Proposal for changes to Regulation No. 121 (Identification of controls, tell-tales and indicators)

I. Proposal

Table 1, amend to read:

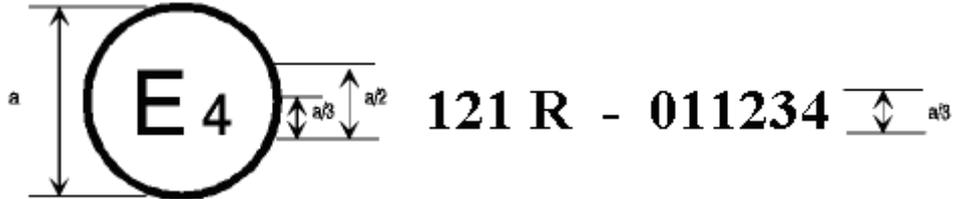
No.	Column 1	Column 2	Column 3	Column 4	Column 5
	ITEM	SYMBOL <u>2/</u>	FUNCTION	ILLUMINATION	COLOUR
...
43.	Electronic stability control (including malfunction)	 or ESC <u>17/</u>	Tell-tale	Yes	see Regs 13-H and 13-as-appropriate Yellow
44.	Electronic stability control system “OFF”	 OFF or ESC OFF <u>17/ 20/</u>	Control	Yes	
			Tell-tale	Yes	Yellow

Add a new footnote 20/, to read:

20/ The supplementary letters "OFF" may be positioned on or adjacent to the outline of the symbol of item No. 43. The font of the letters 'OFF' or 'ESC OFF' is not intended to be restrictive."

Model B

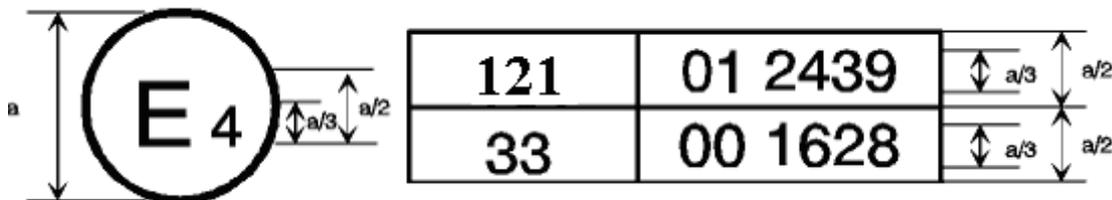
Annex 2, approval mark models A and B, amend to read:

The above approval mark affixed to a vehicle shows that the vehicle type concerned has been approved in the Netherlands (E4) pursuant to Regulation No. 121 and Regulation No. 33¹. The approval number indicates that, at the dates when the respective approvals were **granted in accordance with** Regulation No. 121 **as amended by the 01 series of amendments and with** Regulation No. 33 **which** was still in its original form.
